Moser Pass
Case File: LU 2020-020 PUD/SUB
Final Development Plan

To: Planning Commission

Proposal: On March 7, 2023, City Council adopted Ordinance 2023-001 approving a Planned Unit Development (PUD) and Subdivision to be known as Moser Pass PUD (Case File LU 2022-020 SUB/PUD). The applicant now proposes a Final Development Plan and Final Subdivision Plat for the PUD. Like the approved project, the Final Development/Subdivision Plat proposes a 30-lot residential subdivision and PUD with a community park on a 12.36-acre property. The property is zoned Very Low Density Residential (VLDR) and is in the Southeast Sherwood Master Plan area. The applicant is proposing a minimum lot size of 10,000 SF and overall density of approximately 3.06-units per acre.

Exhibit 2

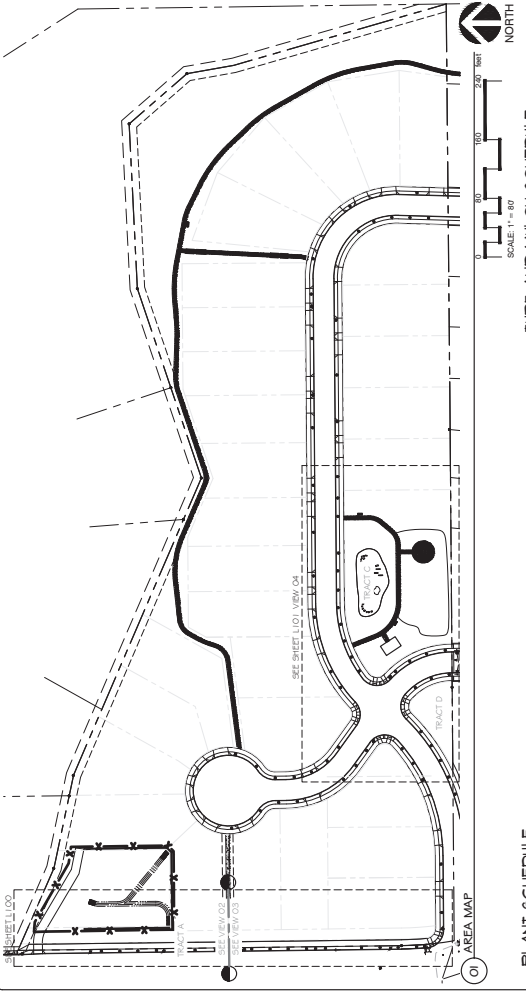
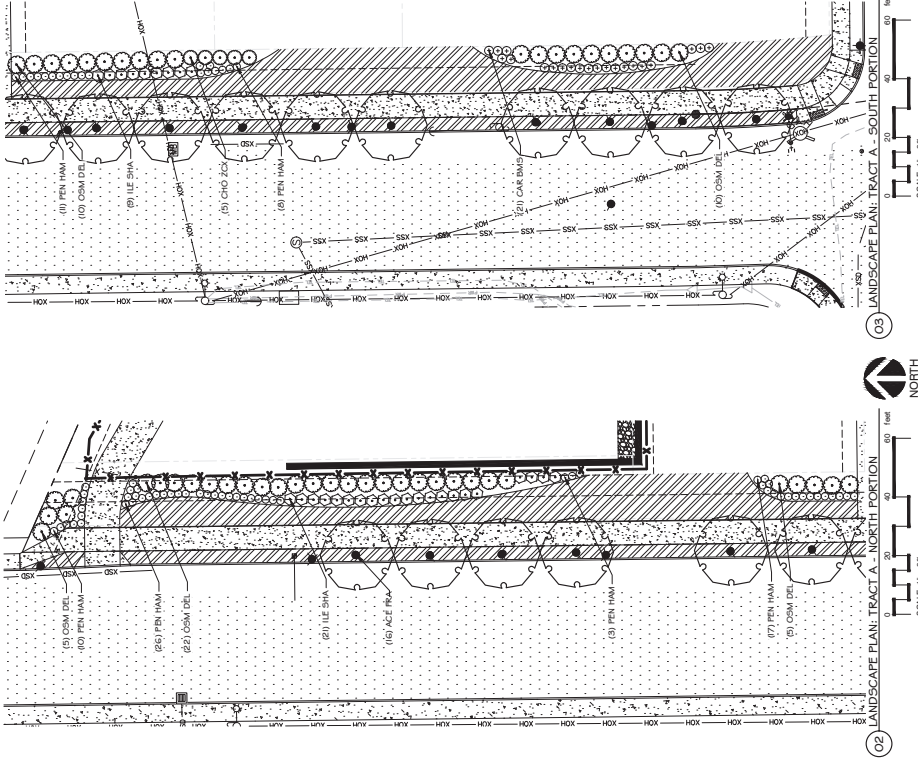
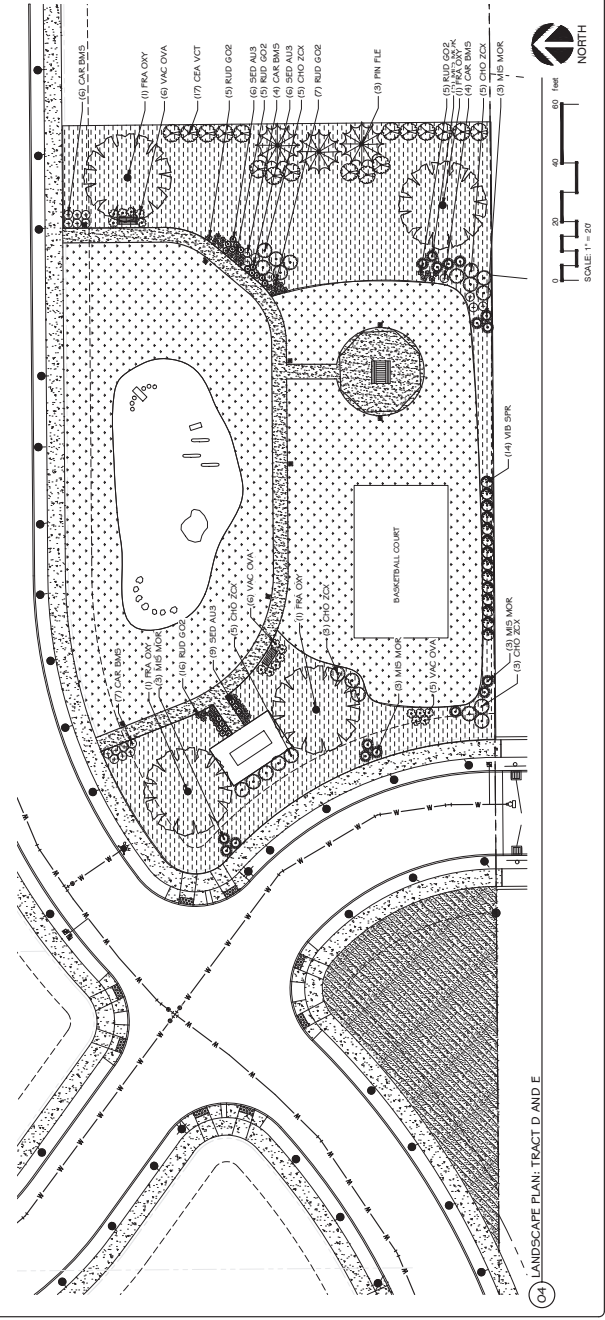
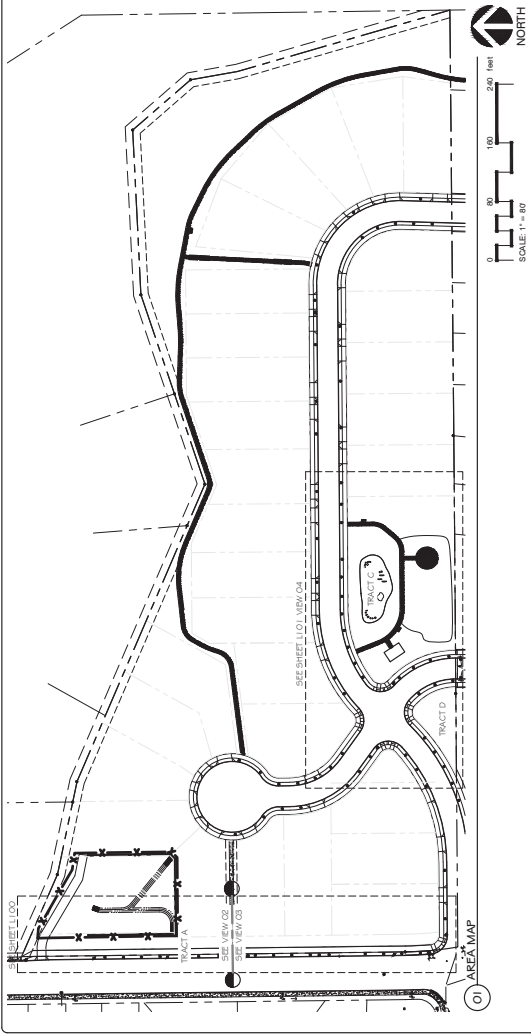
5. Prior to Final Development Plan approval, provide a final Landscape Plan (including open space improvements) and Forest Restoration Plan.

The Landscape and the Forest Restoration Plans must be certified by a licensed landscape architect and a Certified Arborist. Please provide their certification stamps.

Applicant Response: The applicant has included the updated Landscape Plan with appropriate certification information by the required professional. Also included in this submittal is a memo by the project Arborist certifying the Forest Restoration Plan.

Sheet Title: Landscape Plan
 Tract D & E
 Drawing: L101

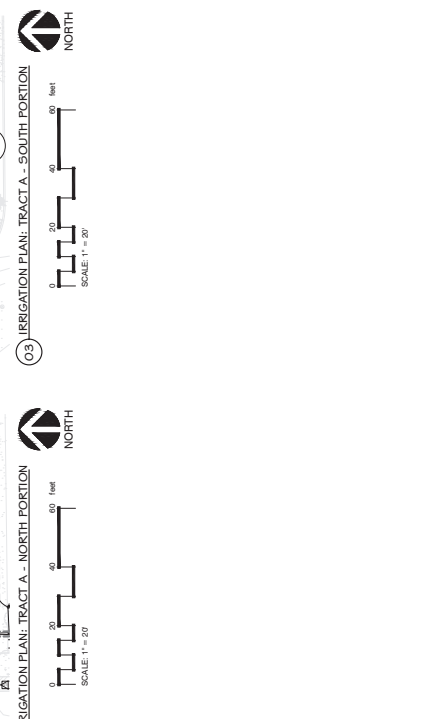
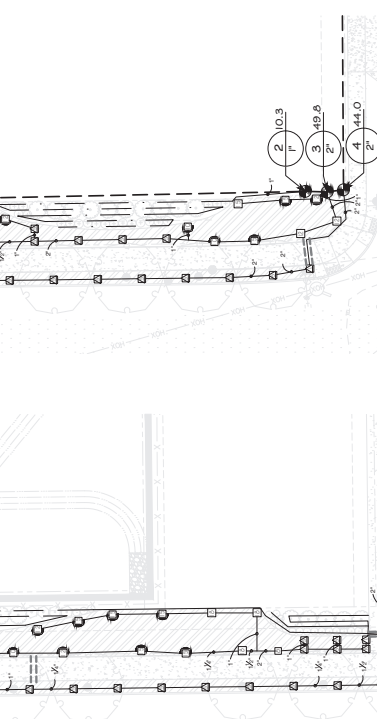
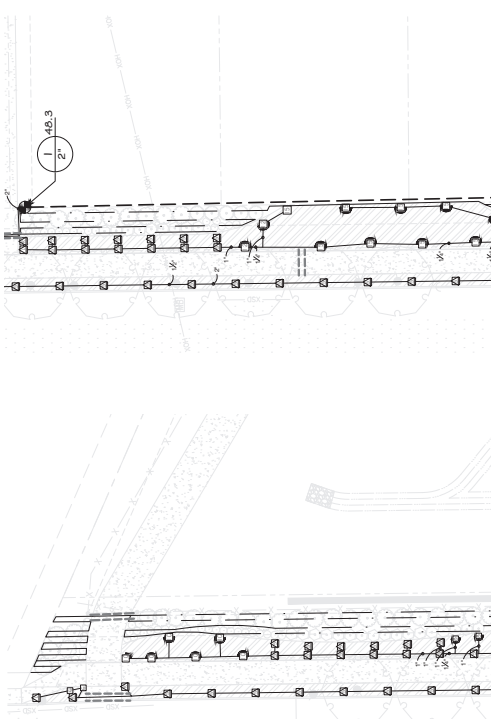
ANALYSIS: Sheet L101 of the Applicant's Exhibit 2 includes trees and landscaping as part of the community park.
